# PCN-20210119a TE0713-02 DDR3 Change (Revised)

<b>Company</b>	Trenz Electronic GmbH
<b>PCN Number</b>	PCN-20210119a
<b>Title</b>	TE0713-02 DDR3 <del>and Flash</del> Change
<b>Subject</b>	BOM change
<b>Issue Date</b>	(2021-01-19), Revised 2021-03-09

This change affects all Trenz Electronic TE0713 SoMs of revision 02: TE0713-02-\*

### #3 Set S/N to not fitted

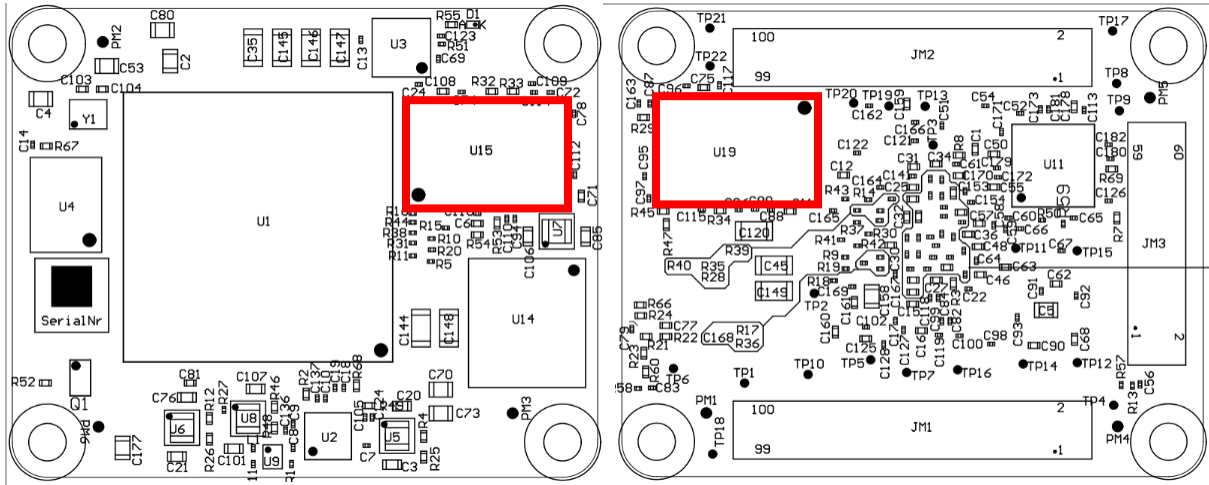
**Type:** BOM change

**Reason:** Part is end of life.

**Impact:** Track it pad no more available.
